AMENDMENT OF SOLICITATION/MODIFICATION OF CONTRACT			1. CONTRACT ID CODE	PAGE 1 OF 6 PAGES
2. AMENDMENT/MODIFICATION NO. AMENDMENT NO. 0002		3. EFFECTIVE DATE 08/27/14	4. REQUISITION/PURCHASE REQ. NO.	5. PROJECT NO. (If applicable) 14-0090
6. ISSUED BY CODE		mks	7. ADMINISTERED BY (If other than Item 6) CODE See Item 6	
Officer in Charge of Construction MCI-East 1005 Michael Road Camp Lejeune, NC 28547-2521				
8. NAME AND ADDRESS OF CONTRACTOR (No., street, county, State and ZIP Code)			(X)	9A. AMENDMENT OF SOLICITATION NO. N40085-14-R-0090
			X	9B. DATED (SEE ITEM 11) 08/20/14
				10A. MODIFICATION OF CONTRACT/ORDER NO.
				10B. DATED (SEE ITEM 11)
CODE	FACILITY CODE

14-0090 Interior/Exterior Repairs, Building FC120

Incorporate revised sheets FA-1, FA-2, FP-1, and FP-2 into the project/contract.

C NEW WET PIPE RISER
 NTS

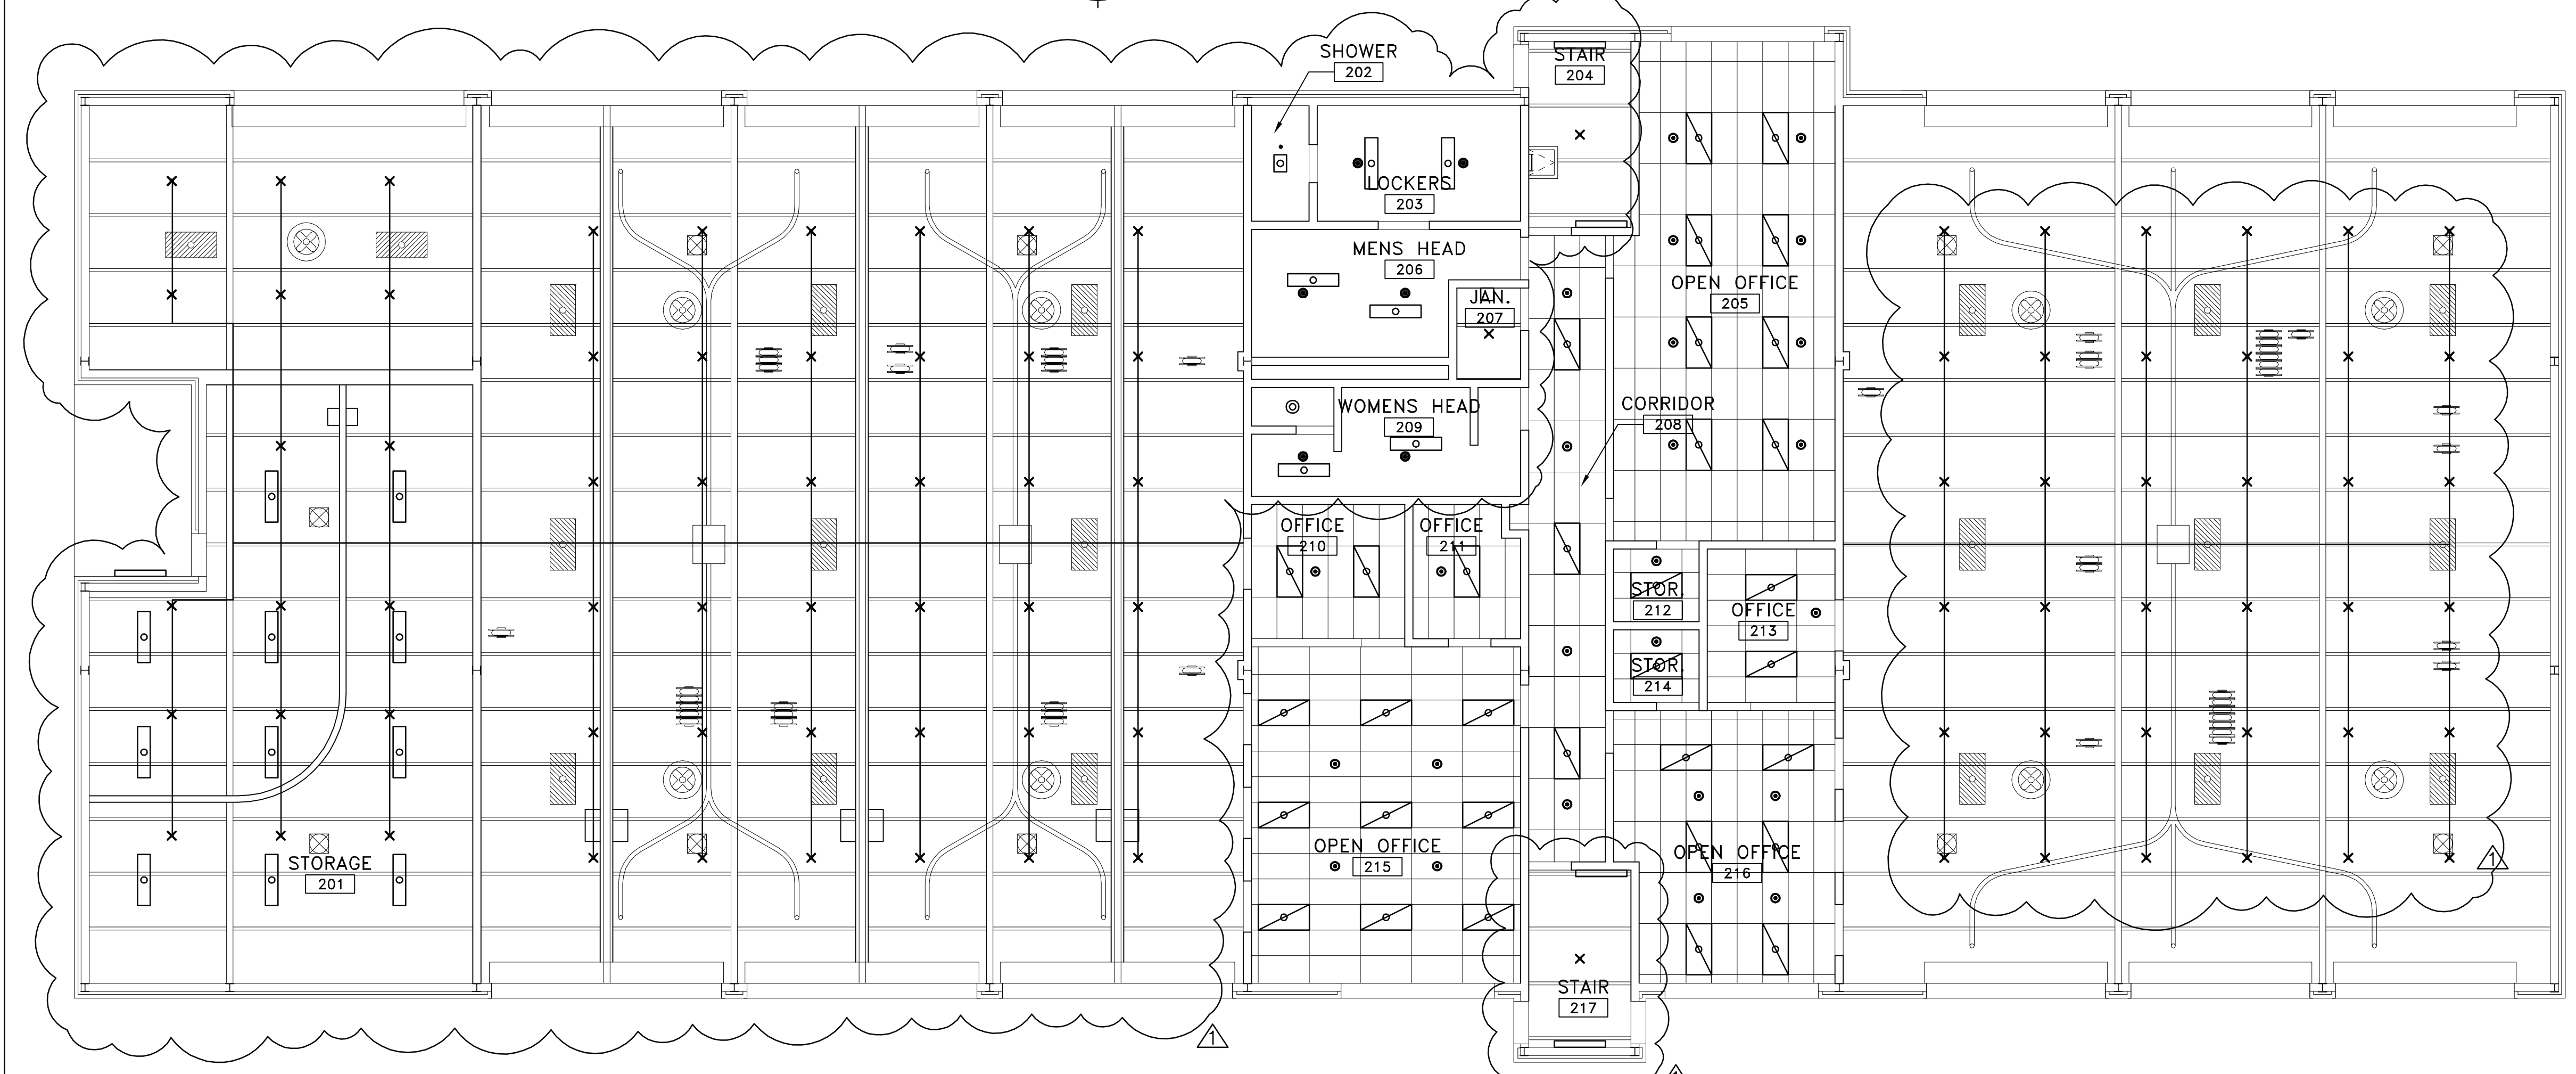
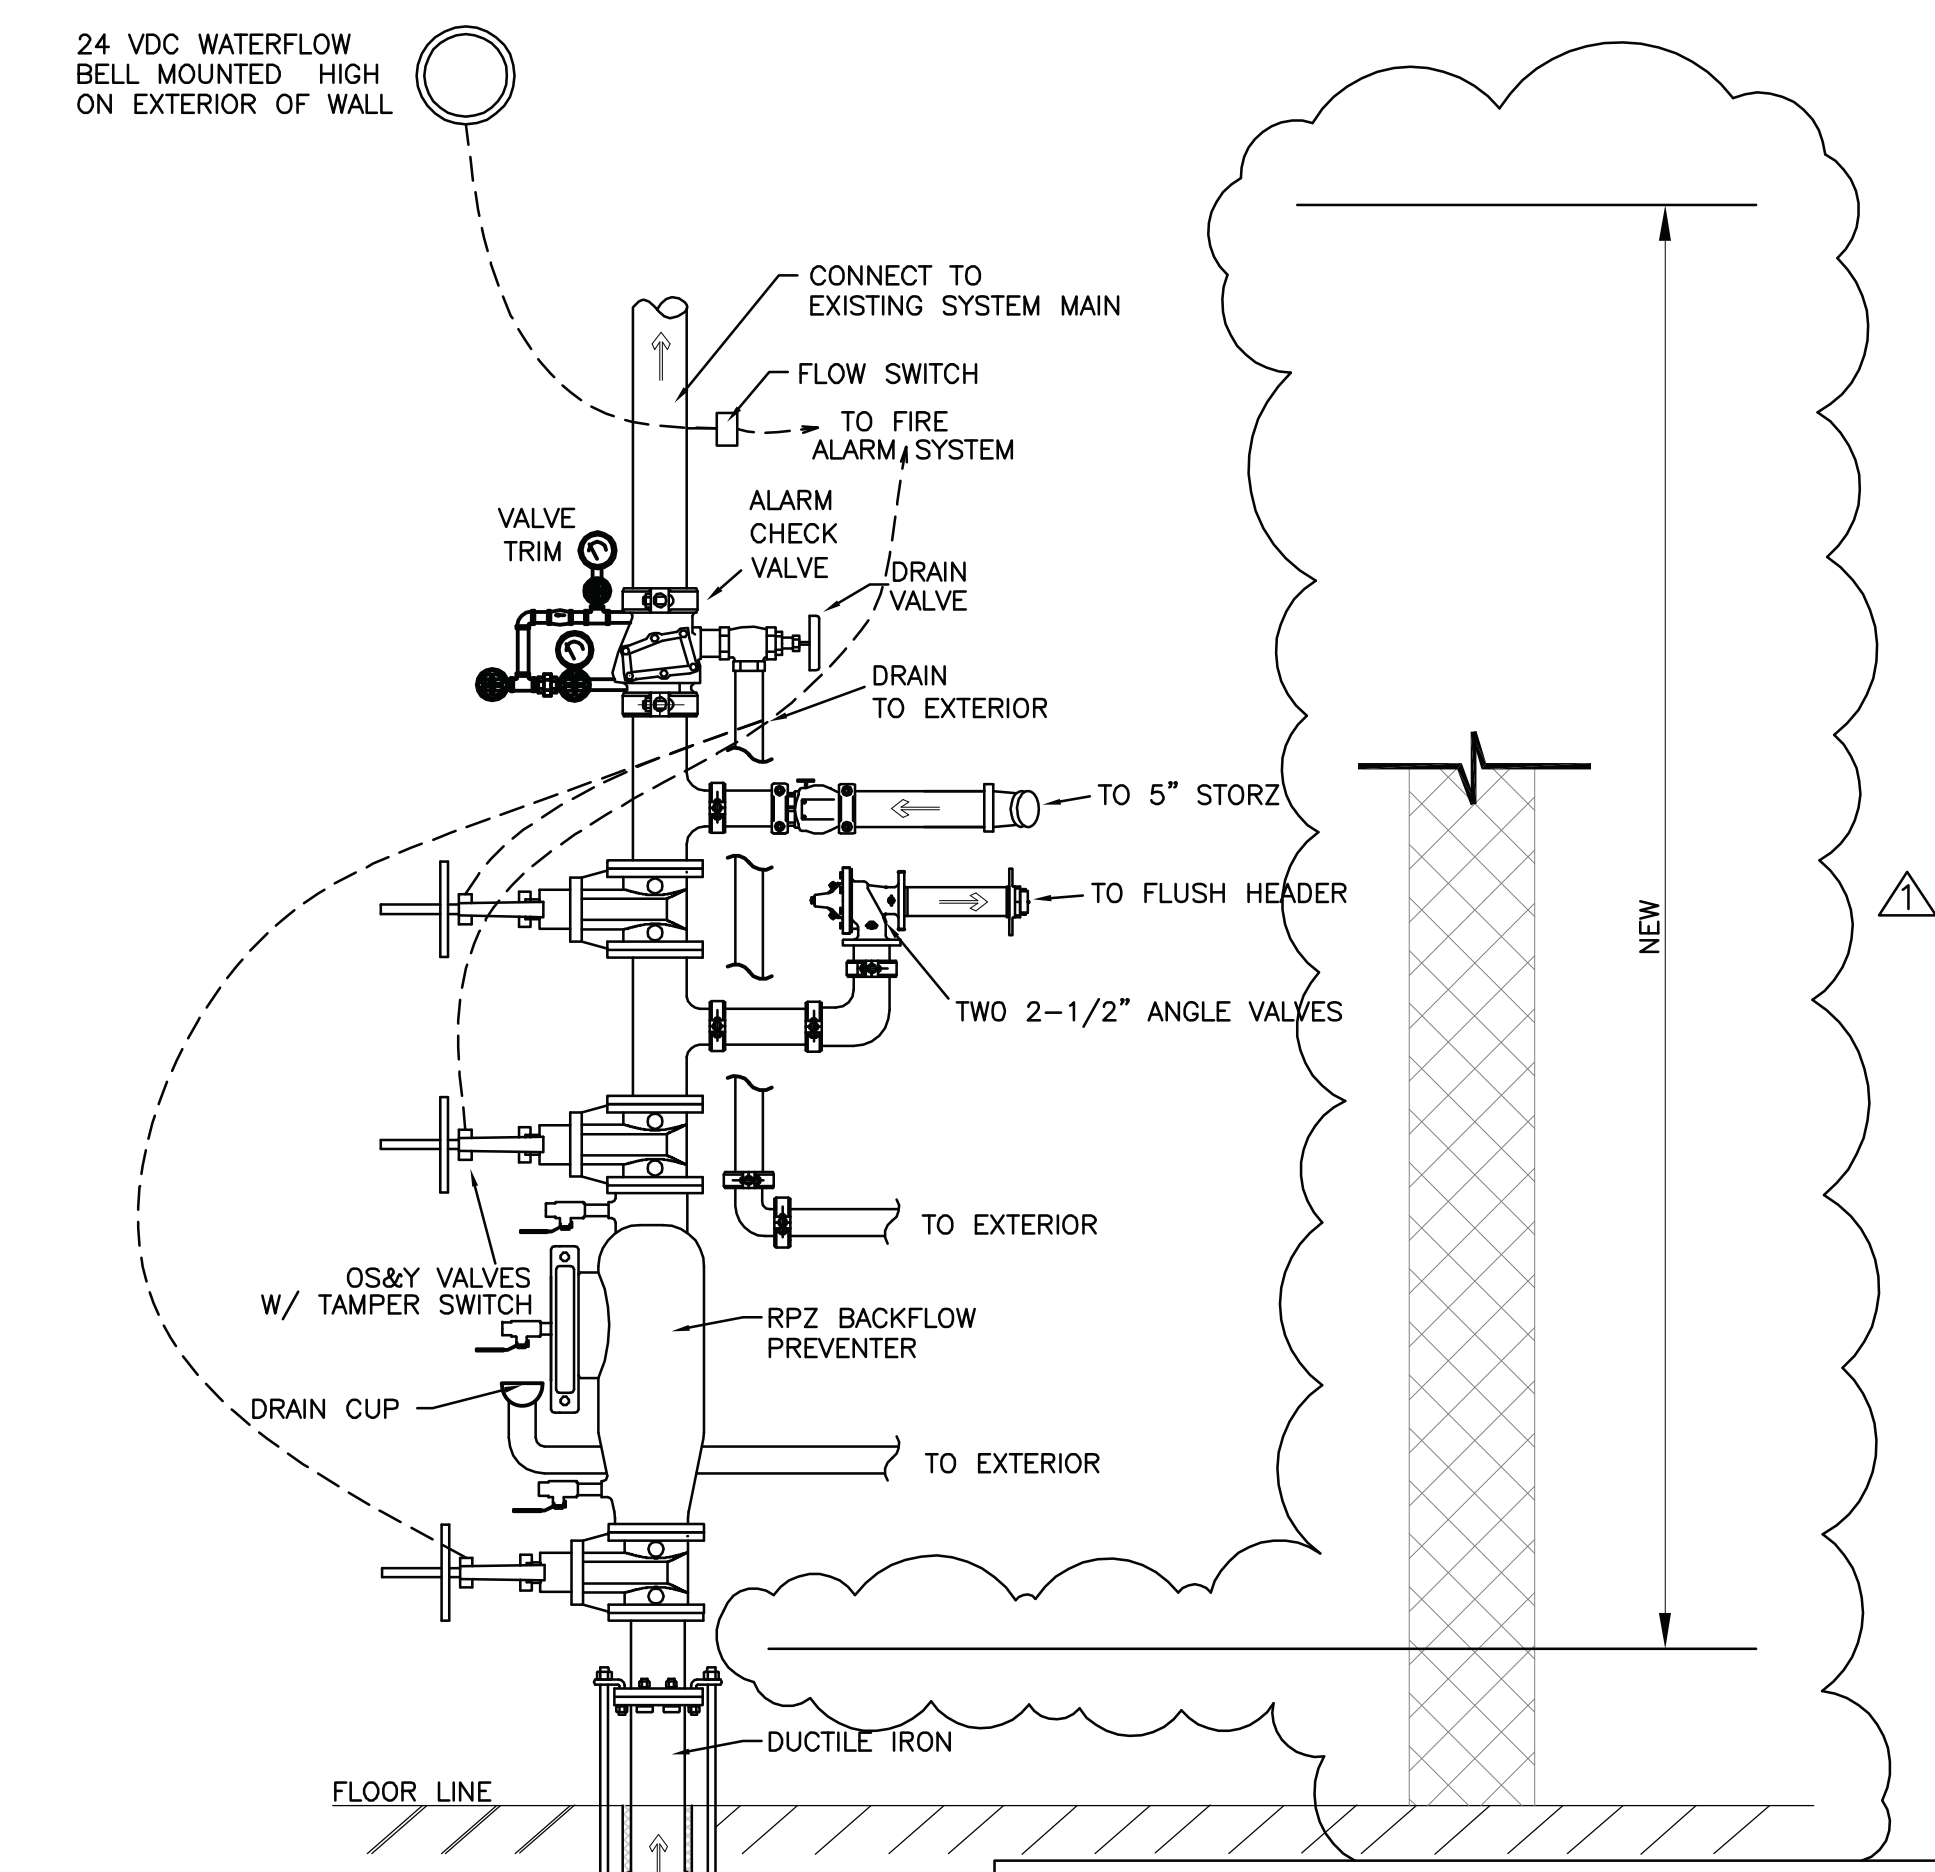
1. FA-2: Provide/install a fire alarm pull station in Storage room 102 on west wall adjacent to the door leading to stairwell.
2. FA-2: Provide/install a speaker strobe in room 114 on west wall adjacent to door.
3. FA-2: Provide/install a FAD beside the new FMCP.
4. FA-2: Provide/install a speaker strobe in room 107 on east wall.
5. FP-2: New Wet Pipe Riser-Omit the Alarm Check Valve and replace with a Flow Switch.
